To: T10 Technical Committee
From: Rob Elliott, HP (elliott@hp.com)
Date: 15 June 2006
Subject: 06-281r0 SAS-2 Enable and disable zoning

Suggested changes to sas2r04 as modified by 06-279

Figure 1 — Physical presence detection introduction

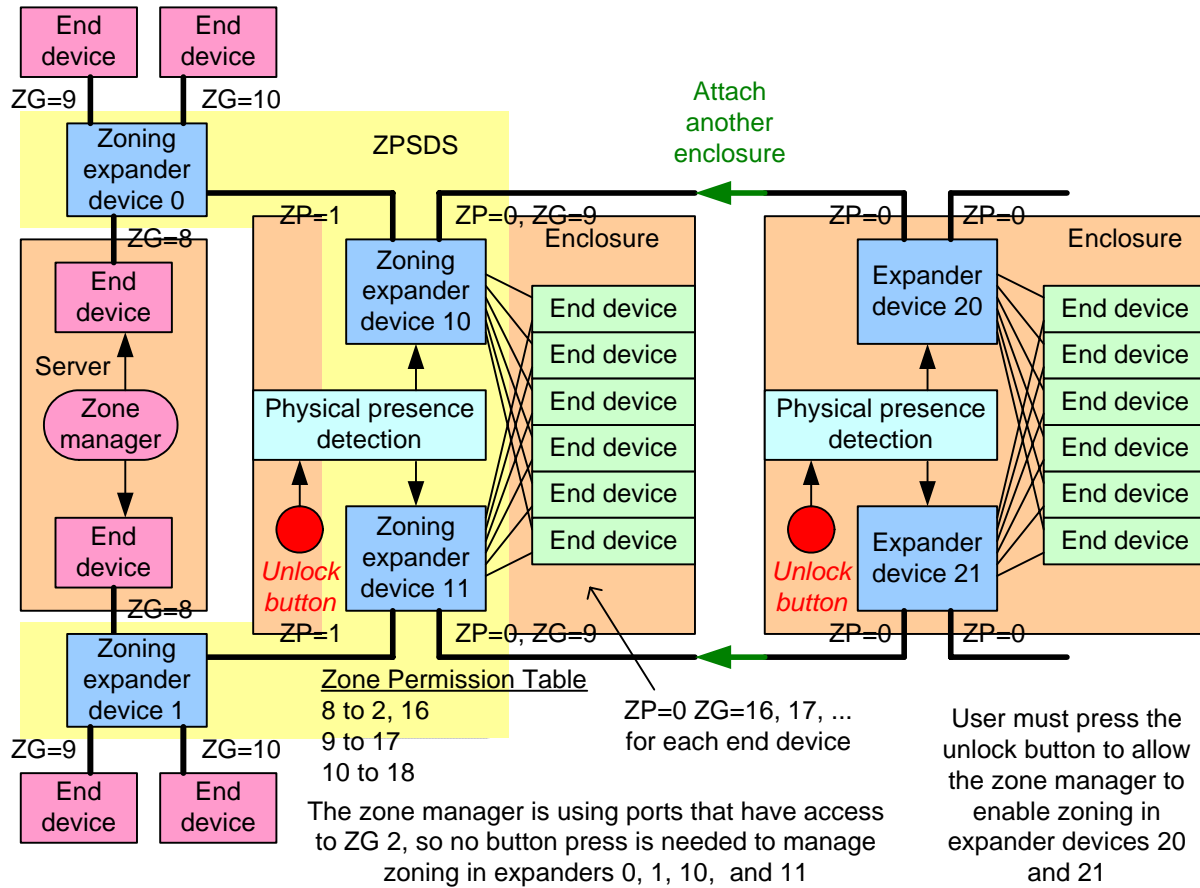
If the new expander device already has zoning enabled and configured (perhaps because it was already a member of a different ZPSDS), probably with incompatible zone group assignments and permissions, then those existing settings need to be removed and reconfigured before it is added to the ZPSDS. If zoning is enabled, then any SMP initiator port with access to zone group 2 is allowed to perform any zoning configuration changes, including disabling zoning. This access must be carefully limited to trusted components. Note that all expanders inside the ZPSDS are in zone group 1 and thus have access to zone group 2.

One mechanism that can be used to address this problem is physical presence. If an expander knows that a user is physically present, it can allow zoning to be enabled or disabled.

Figure 1 shows an enclosure (e.g., a JBOD) being added to an existing ZPSDS.

Figure 8 — Physical presence detection example

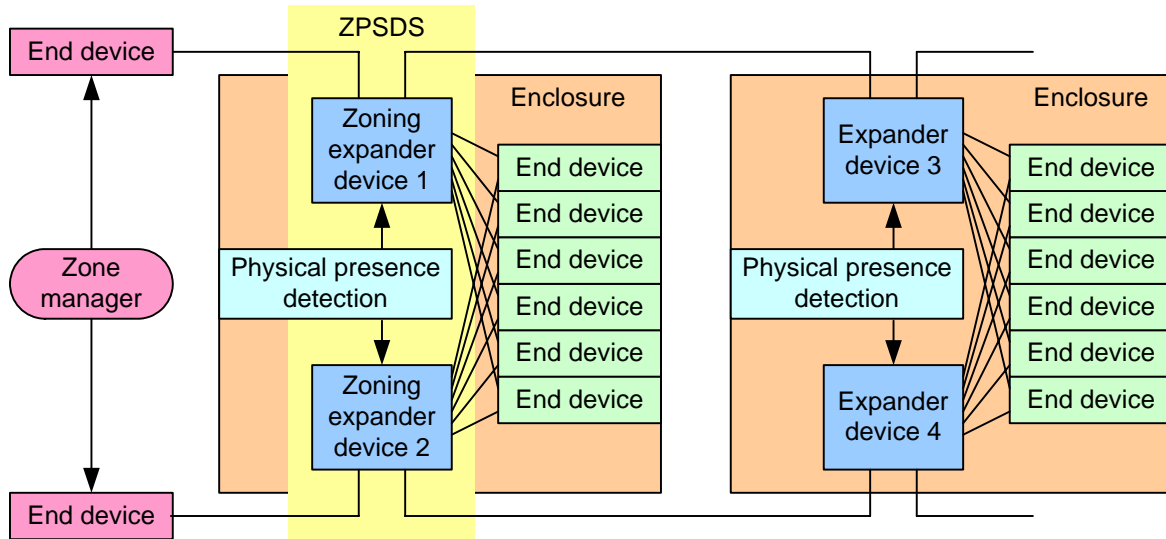
[Figure 8 shows an example of two enclosures, each containing two expander devices that share physical presence detection. Zoning is enabled in the expander devices in the left enclosure, but is not enabled in the](#)

expander devices in the right enclosure. The zone manager is able to configure zoning in zoning expander device 1 and zoning expander device 2 because the zone group of each SMP initiator port has access to zone group 2. However, it is not able to configure zoning in expander device 3 and expander device 4 unless physical presence is asserted.
